(CBM Caledon Quarry)

CAART COMMENT SUMMARY TABLE RESPONSE #1 – [BLASTING]

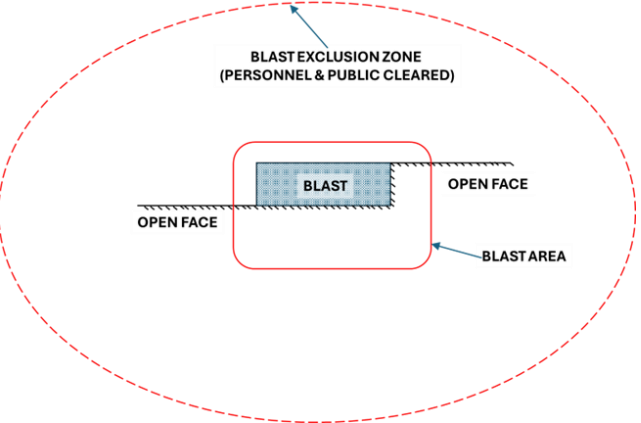
5.	The drawing shows the best estimate of the area where the depth of rock excavation would exceed 25 meters. This should be clarified in the report text. RESPEC recommends splitting the bench into two benches of approximately equal height as the pit wall approaches 25 meters in height to allow recovery of all resources. Having a bench of 25 meters and a secondary bench of 3 meters where the final wall height is 28 meters would not be economical or practical. This proposed split would also reduce the explosive loading per delay for each blast, lowering potential vibration levels (see bullet on page 5 [Page 24, Table 2]).	Blast Impact Assessment: Page 9, Figure 5	As the quarry wall approaches 25 meters (m), the bench will be split into two benches of approximately equal height to allow recovery of all resources. This would result in a maximum bench height of approximately 25 m as shown in Table 2. The vibration monitoring records will inform when bench height should be split in order maintain compliance with the regulatory limits.

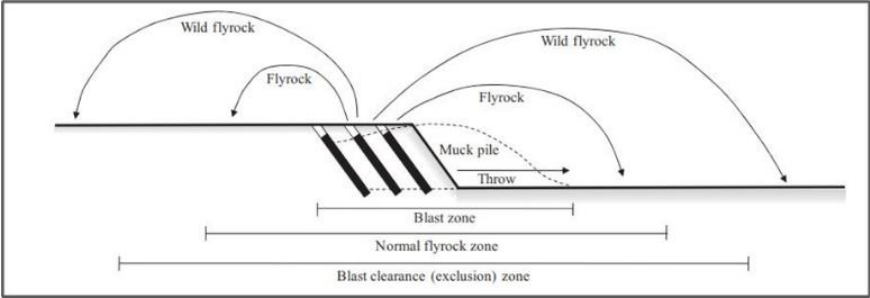
13.	The data supplied from the Osprey Quarry consisted of air overpressure readings at different ranges insufficient to generate an air overpressure attenuation model. Air overpressure regression curves are difficult to generate with high accuracy as weather conditions make a significant difference in readings. However, Figure 9 presents industry standard equations to use as a starting point for quarry development. RESPEC verified these	Blast Impact Assessment: Page 18, Section 5.3	Acknowledged. No action is required.

Initial CAART Comments (Date)	Page / Section	Applicant Response (January 15, 2025)	CAART Response (Date)
	equations by reviewing supporting documentation and performing validation checks. A more accurate site-specific model will be developed as ongoing monitoring occurs throughout the quarry development.
